# Work Order ID 90966

Item Name: Crosstube Mid Fwd, Blue

<b>DART AEROSPACE LTD</b> HAWKESBURY, ONTARIO, CANADA	
DRAWING NO. D206-667-147	REV. A SHEET 1 OF 4
TITLE CROSSTUBE ASSY (206L MID FWD)	SCALE NTS

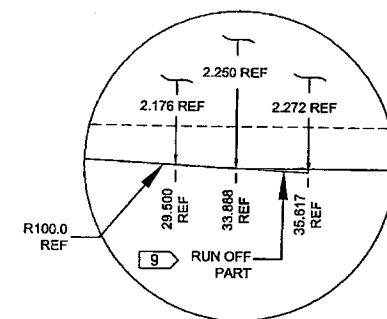
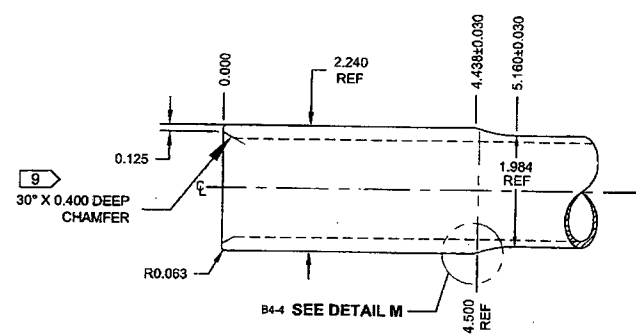
REPLACE MAGNOBOND WITH PROSEAL.

NOTE 12 &amp; 15, SHEET 1 IS AMENDED AS FOLLOWS:

- 12) TO INSTALL D2891-1 SUPPORT: ABRASE MATING SURFACE OF SUPPORT AND CROSSTUBE WITH 180-GRIT SANDPAPER AND REMOVE RESIDUE WITH MEK (OR EQUIVALENT). APPLY A 0.04" TO 0.07" THICK LAYER OF PROSEAL 890 CLASS B-2 (OR AMS-S-8802 CLASS B-2) SEALANT TO MATING SURFACE OF SUPPORT.
- 15) TORQUE CLAMPS 80 TO 100 IN-LB. ENSURE AT LEAST 1.5 THREADS SHOWING IN SAFETY AND THAT NUT HAS NOT BOTTOMED-OUT AFTER TORQUING. **PRIOR TO PACKAGING, RE-CHECK TORQUE ON CLAMPS AFTER PROSEAL 890 SEALANT HAS CURED FOR 72 HOURS.**

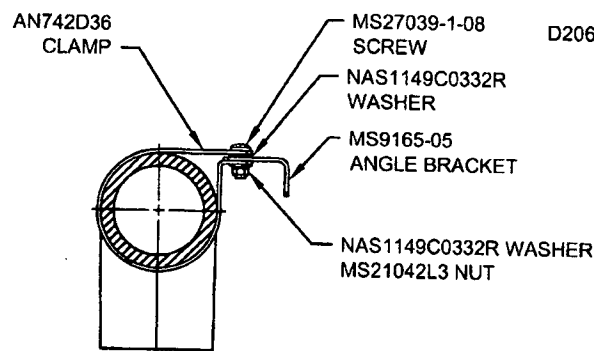
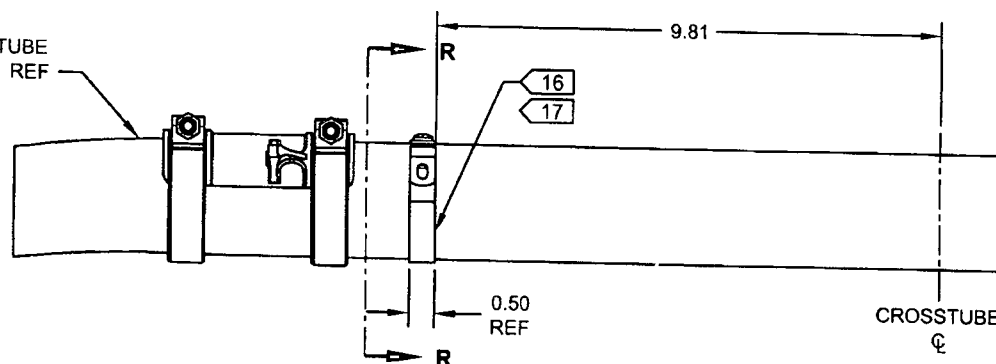
ADD ELECTRICAL GROUNDING STRAP

- 16) MASK AREA UNDER CLAMP PRIOR TO PAINTING
- 17) SEAL EDGES WHERE AN742D36 CLAMP MEETS WITH THE CROSSTUBE USING SIKAFLEX-241/-291 OR MIL-S-8802 CLASS B2 OR PROSEAL 890 SEALANT
- 18) PERFORM RESISTANCE CHECK TO ENSURE MAX RESISTANCE IS 10 MILLIOHMS

**DETAIL P**  
BONDING STRAP INSTALLATION 2 PL

**FIGURE 1 - INSTALLATION OF DART CROSSTUBES ON BHT/AAI SKIDTUBE**

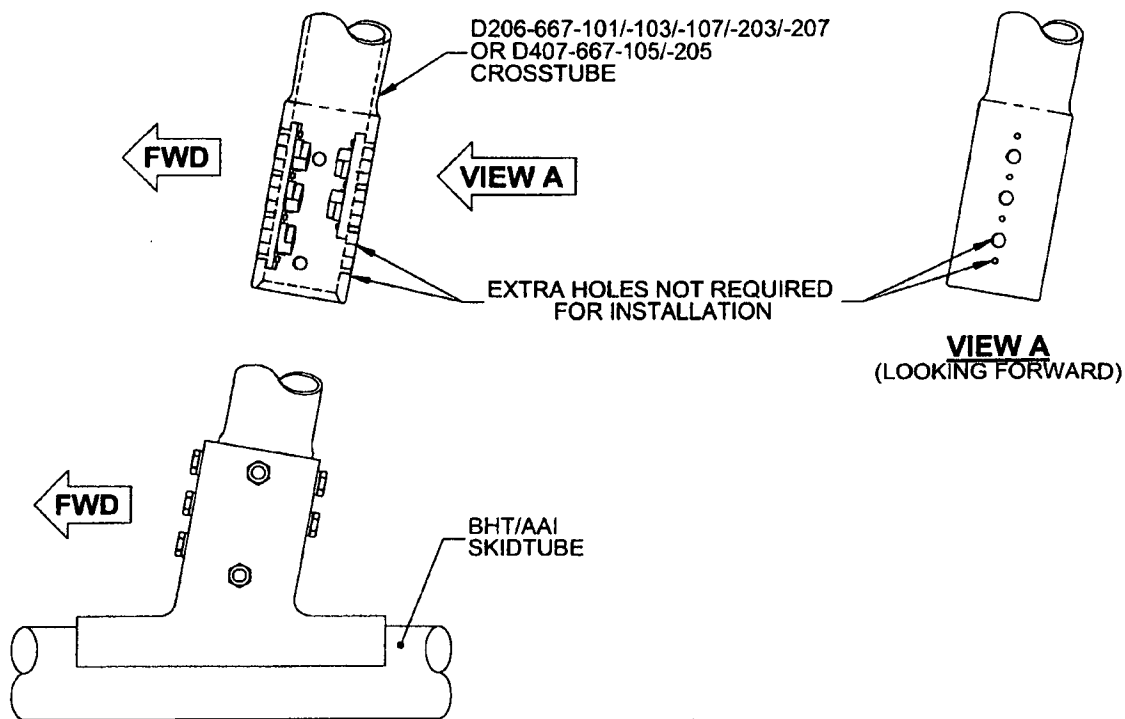
THE FOLLOWING D206-667-101/-103/-107/-203/-207 AND D407-667-105/-205 CROSSTUBES HAVE EXTRA HOLES DRILLED ON THE AFT SIDE OF THE CUFFS. THIS HOLE IS NOT REQUIRED FOR INSTALLATION OF DART CROSSTUBES ONTO BHT/AAI SKIDTUBES AS SHOWN IN FIGURE 1.
